THE PENNSYLVANIA STATE UNIVERSITY

DOCKET NO. 50-5

AMENDMENT TO FACILITY OPERATING LICENSE

Amendment No. 26
License No. R-2

ORGANIZATION CHART

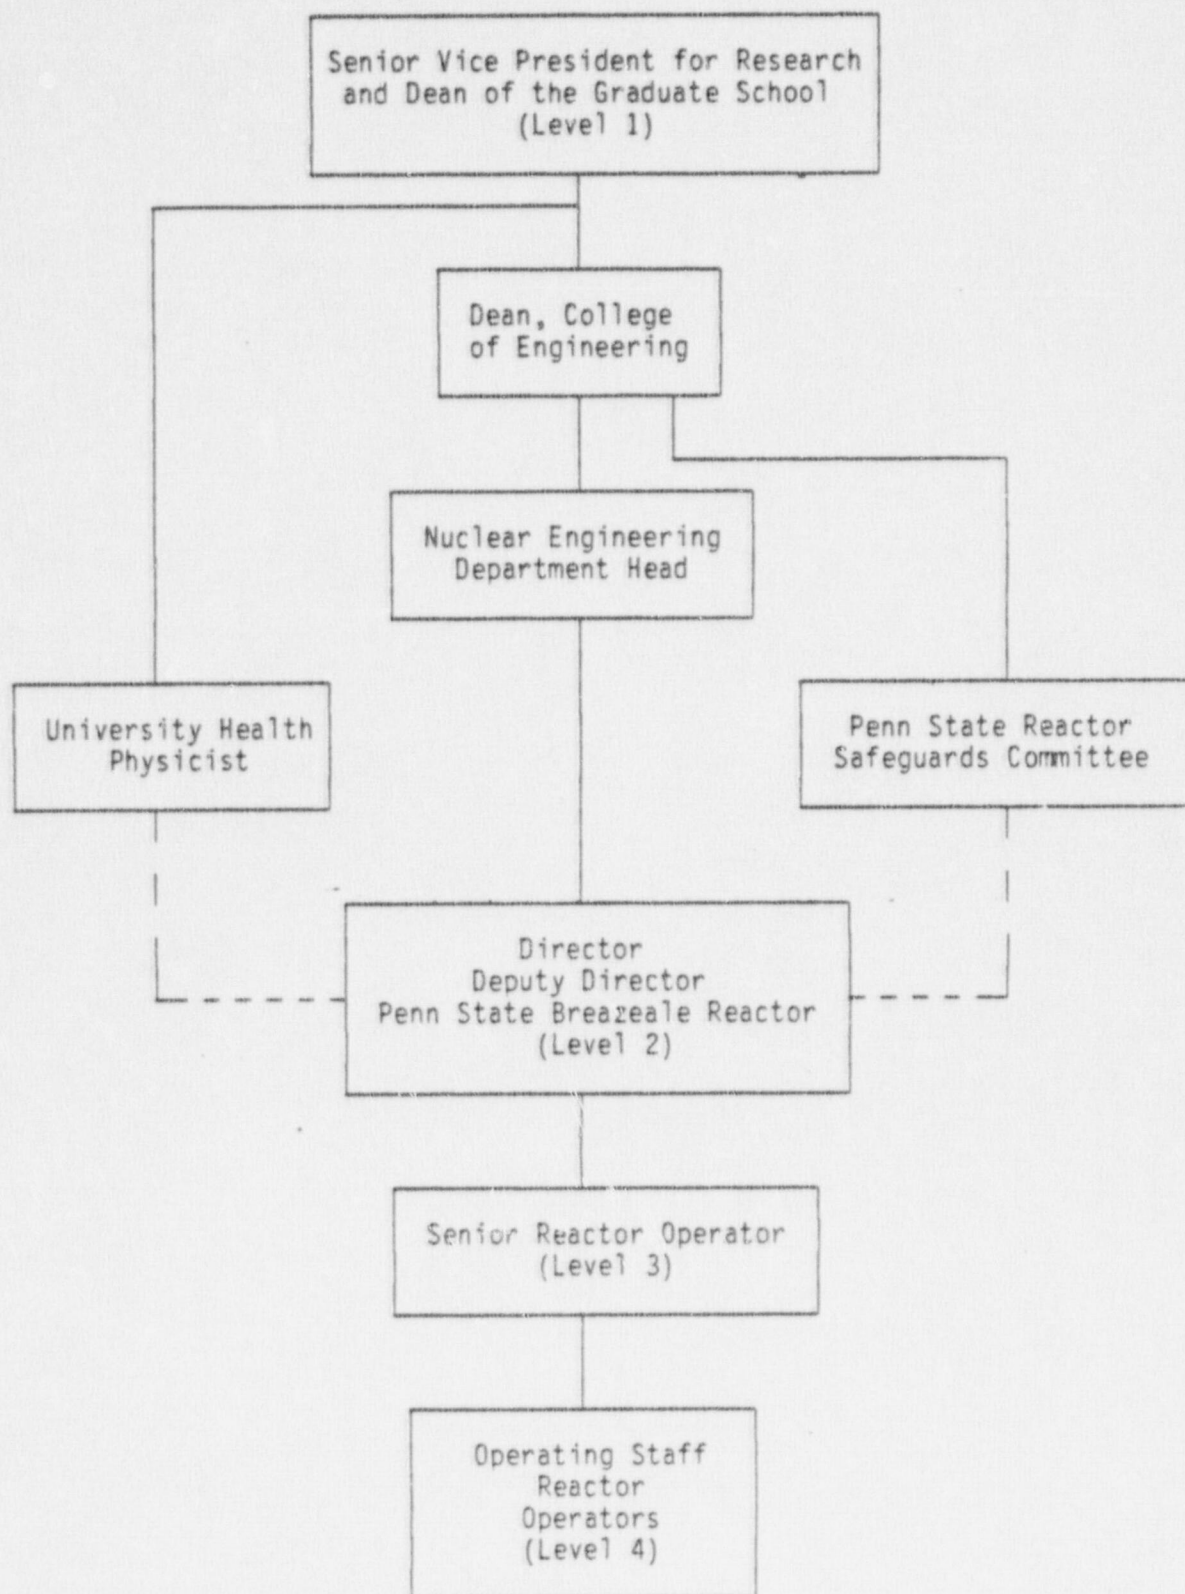
The University Senior Vice President for Research and Dean of the Graduate School (level 1) has the responsibility for the reactor facility license. The management of the facility is the responsibility of the Director and the Deputy Director (level 2), who report to the Senior Vice President for Research and Dean of the Graduate School through the Head of the Nuclear Engineering Department and the Dean of the College of Engineering. Administrative and fiscal responsibility is within the offices of the Department Head and the Dean.

The Director can at any time temporarily delegate his authority to the Deputy Director who can in-turn further delegate his authority to a qualified Senior Reactor Operator (level 3).

The reactor operators (level 4) report to the Senior Reactor Operator (level 3) for operational matters.

The University Health Physicist reports directly to the Office of the Senior Vice President for Research and Dean of the Graduate School. The qualifications for the University Health Physicist position are the equivalent of a graduate degree in radiation protection, 3 to 5 years experience with a broad byproduct material license, and certification by The American Board of Health Physics or eligibility for certification.
